MEMORANDUM

RE: Report on revised Wayland MPS Application: Signage, Landscape,

Streetscape and Lighting

The following is the second review by The Cecil Group of the landscape plans submitted by the applicant for the Wayland Master Special Permit Application for the Wayland Town Center Mixed Use Overlay District (MSP submittal). This memo follows two previous review memos.

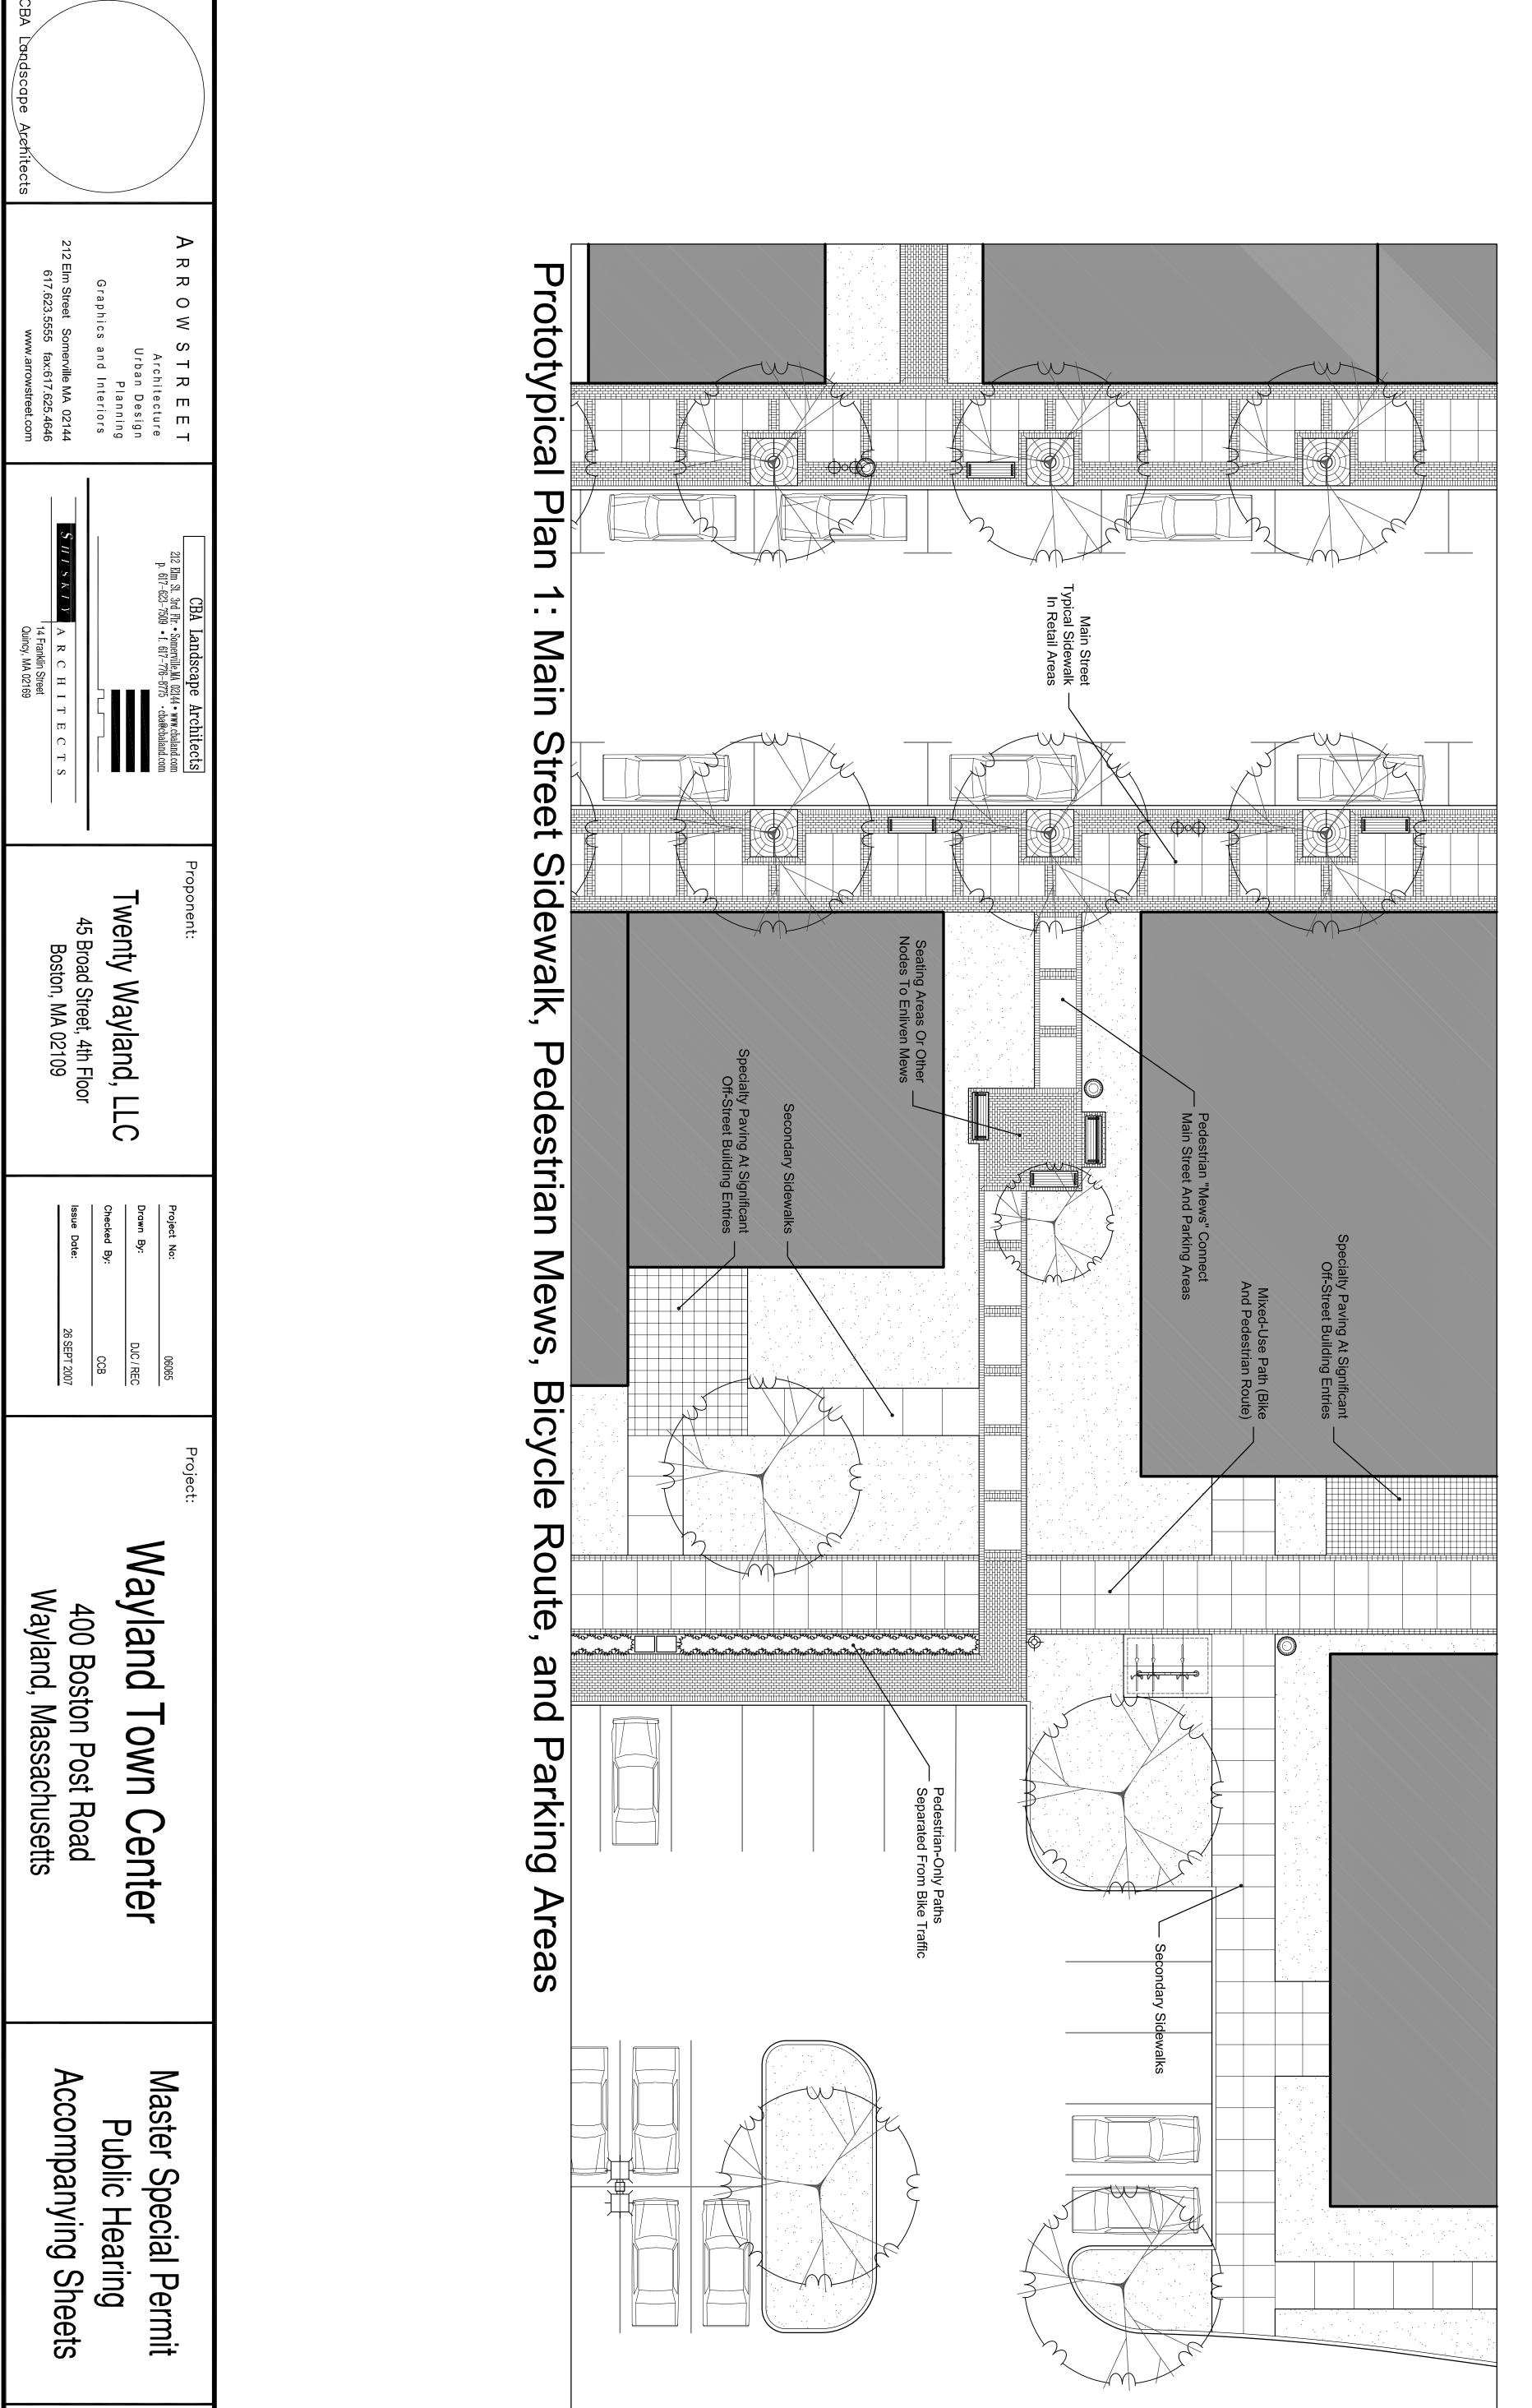
- 4. The cross-section along the bike path shows the suggested plantings along the market building. Although the plantings allow the building architecture to properly become part of the landscape, the Board must make a finding that a "visual buffer" is provided at the loading dock with this plan. A denser buffer may be warranted to meet this criterion at that building and property corner.
